### ADDENDUM NO. 2 November 14, 2023

### Burnet City Hall – RFP 2023-012 PID: CIPSP-2022B

This Addendum forms a part of the Contract and clarifies, corrects or modifies the original Construction Documents, plans dated <u>9/15/2023</u>. Acknowledge receipt of this addendum in space provided on Proposal. Failure to do so may subject bidder to disqualification.

PROJECT NO. 2021-16 PROJECT INFORMATION

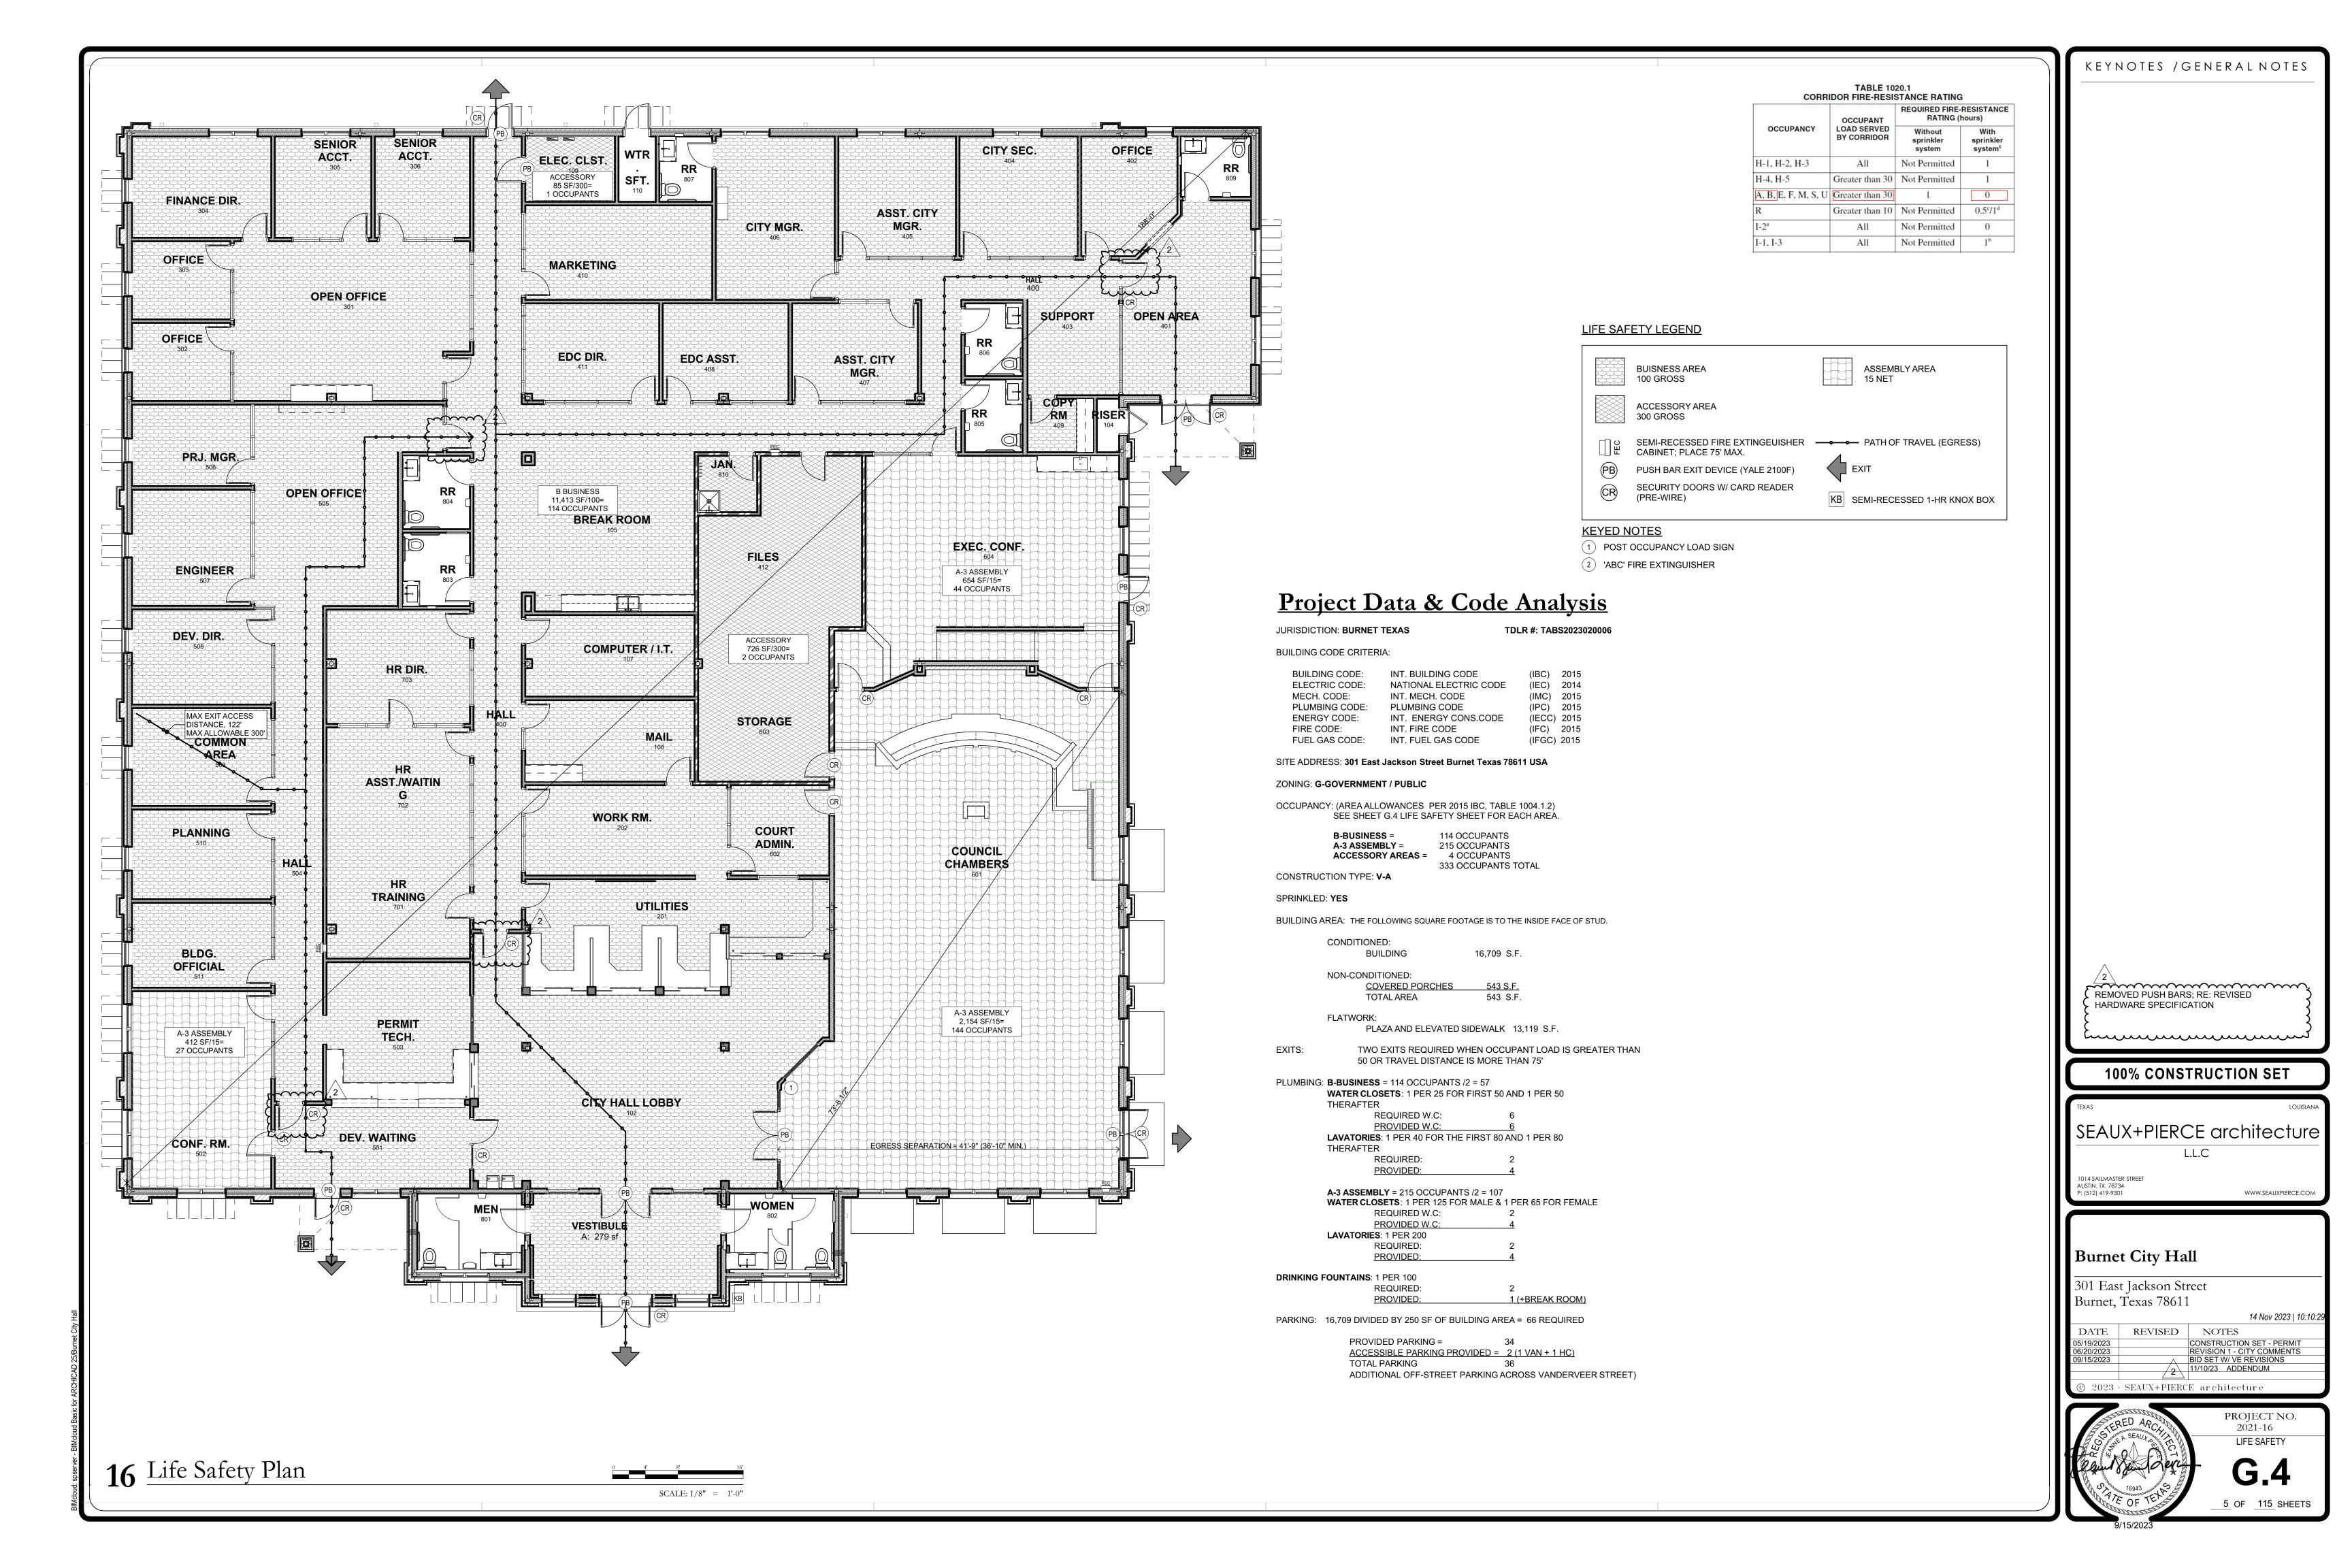
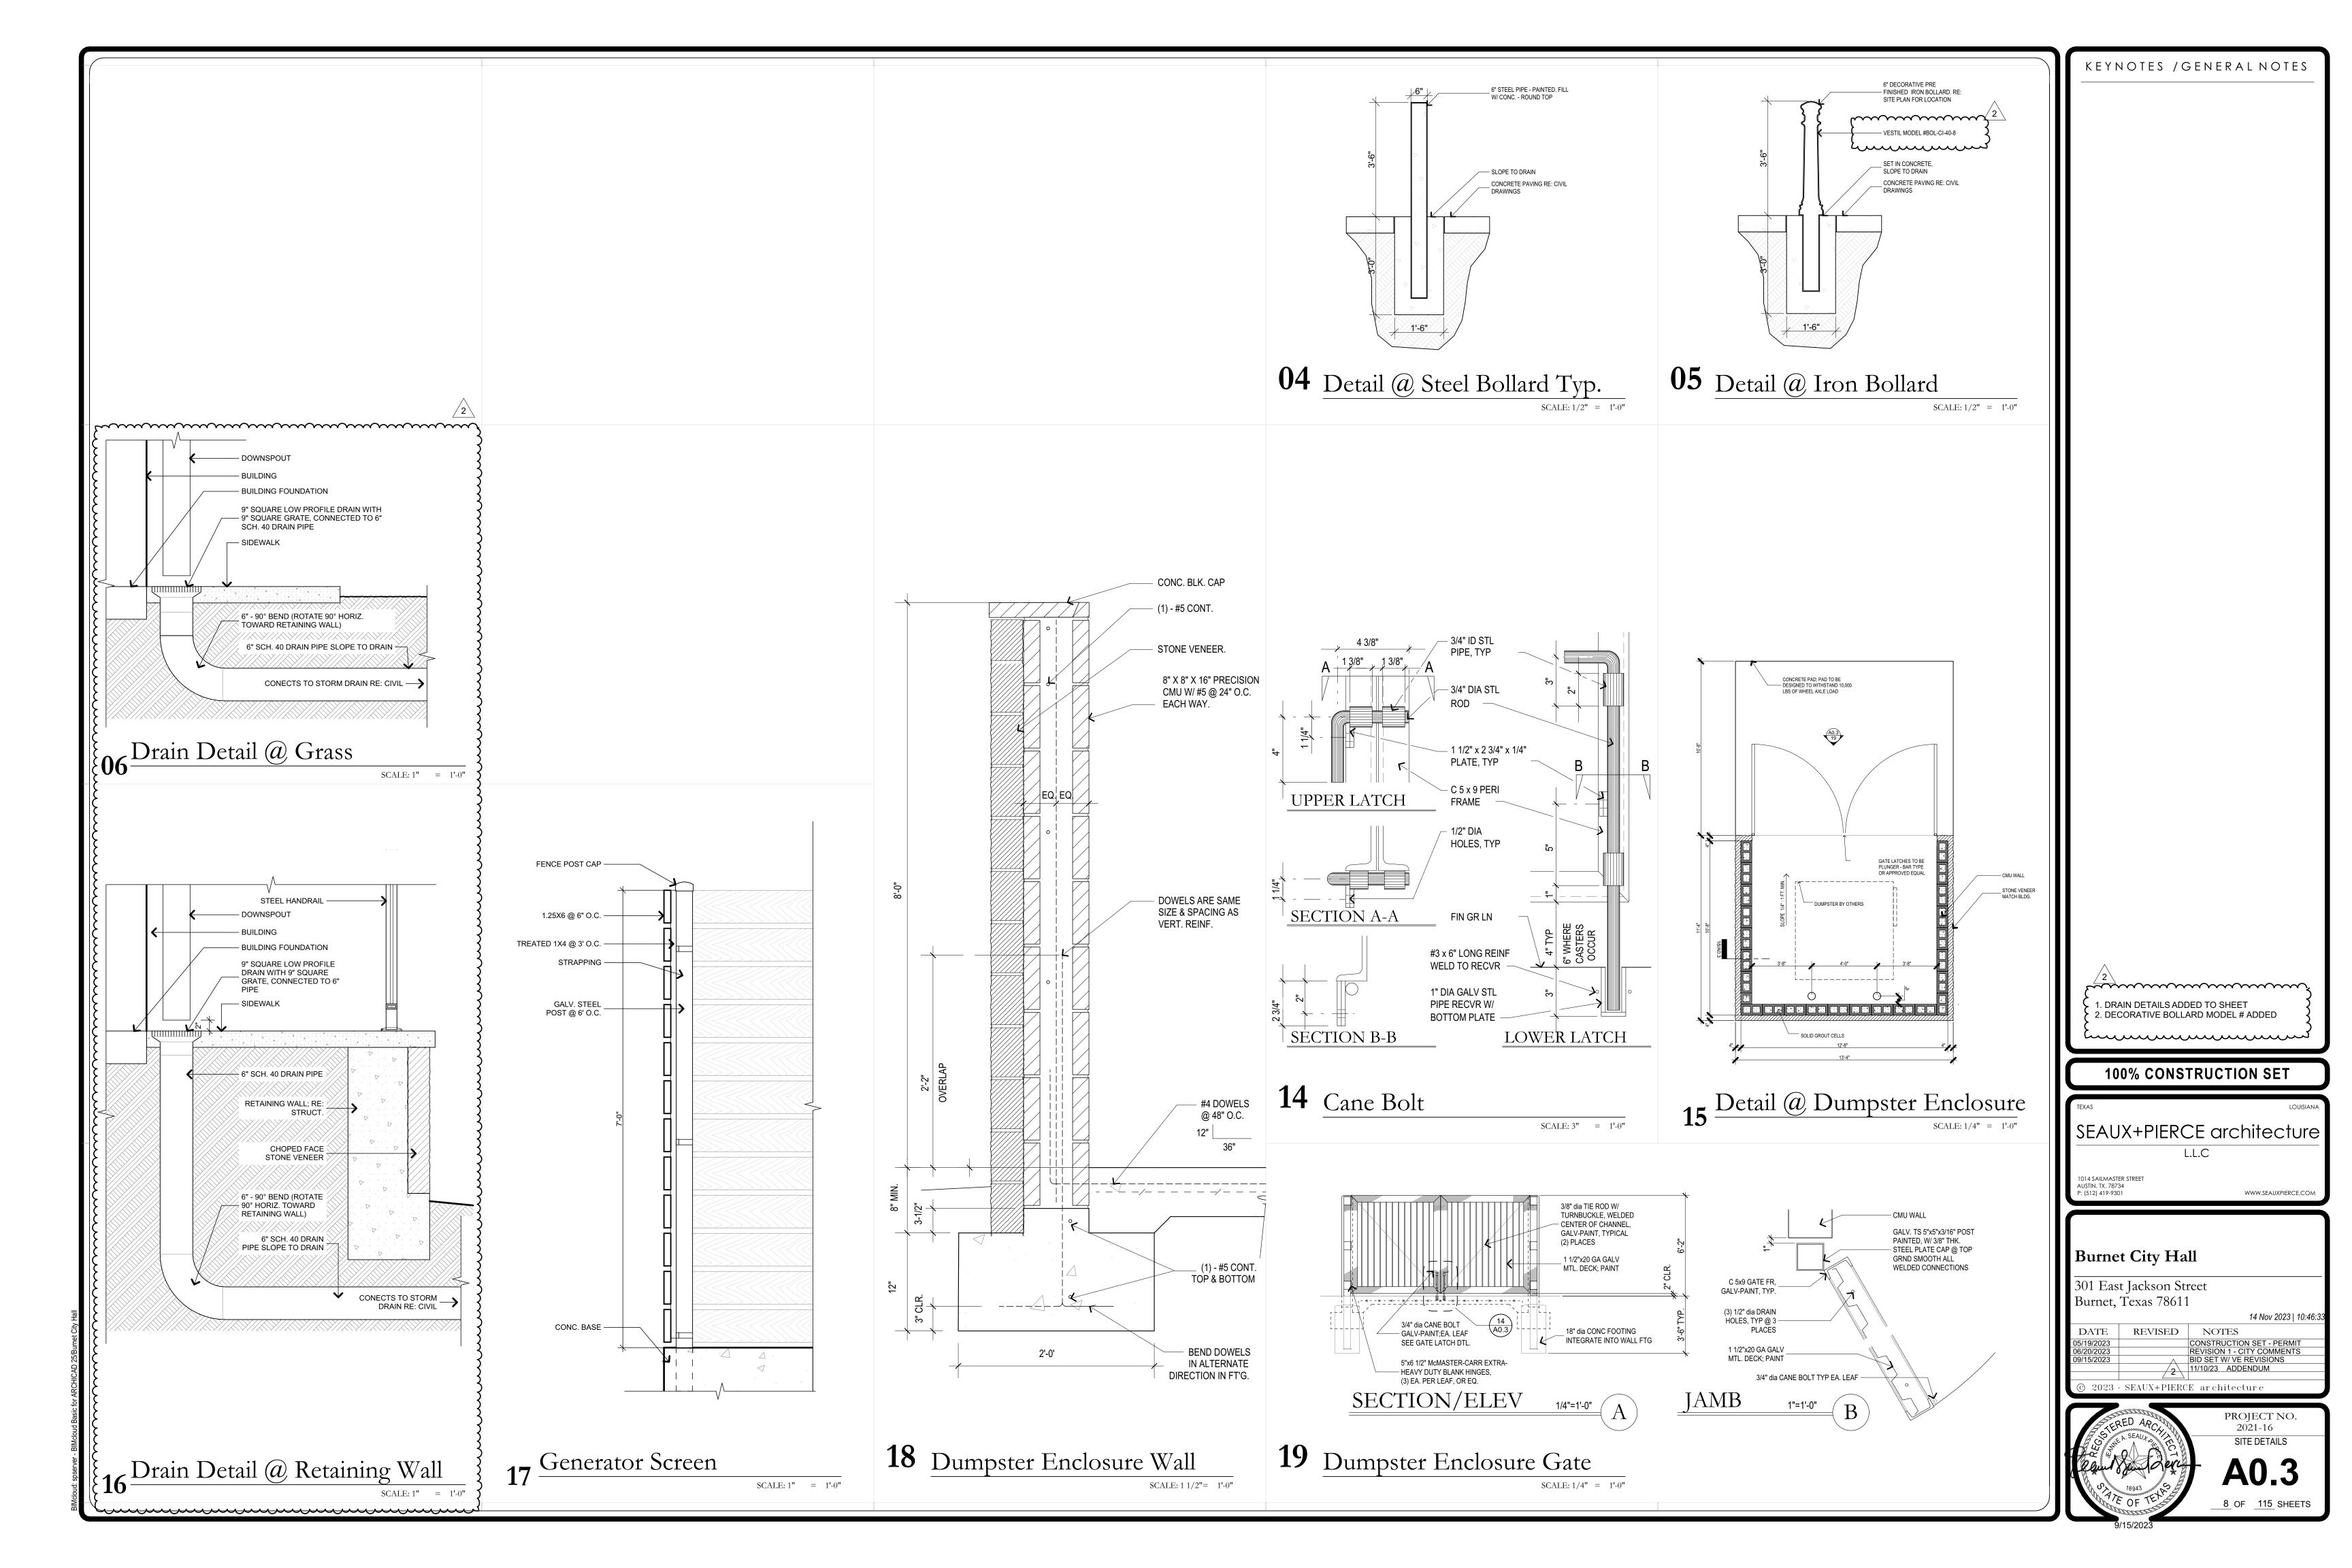
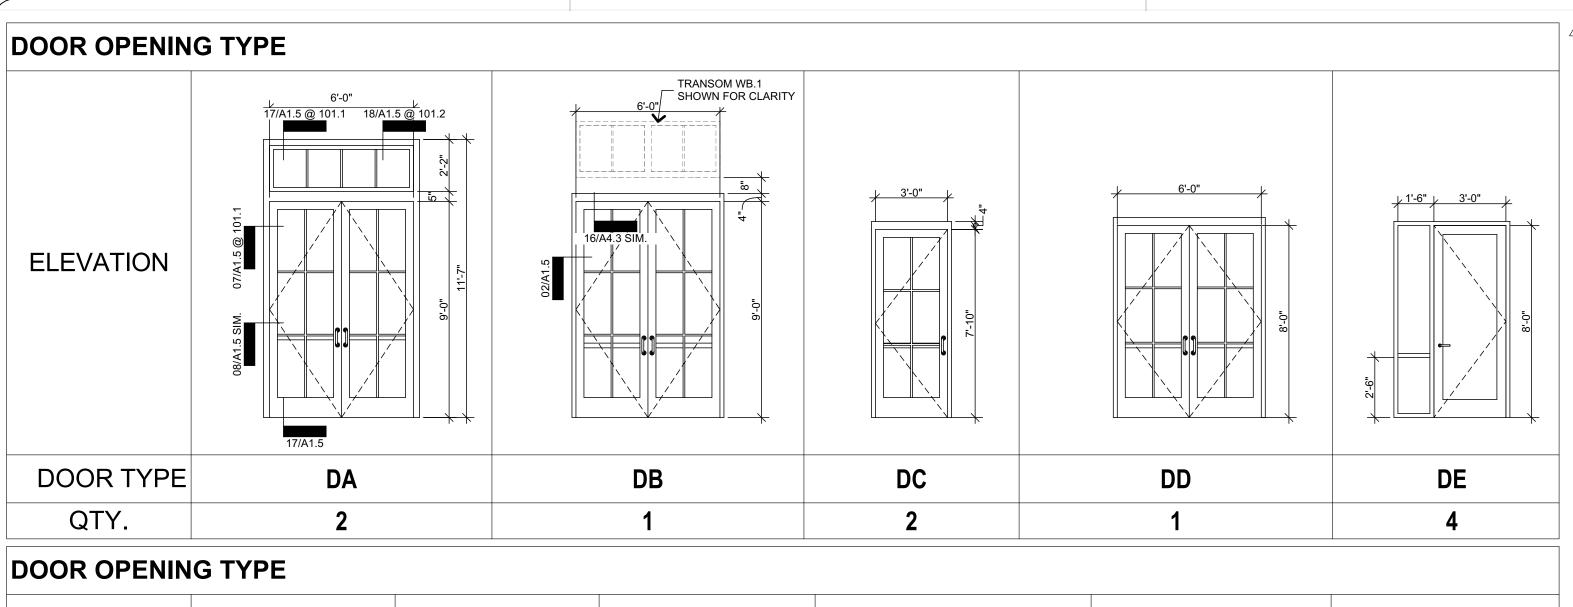
- 3. Sheet G0.1 (Title Sheet)
  - a. Updated Index of Drawings to reflect sheets that have been revised.
- 4. Sheet G.4 (Life Safety)
  - a. Deleted panic bars, re: revised door hardware specification.
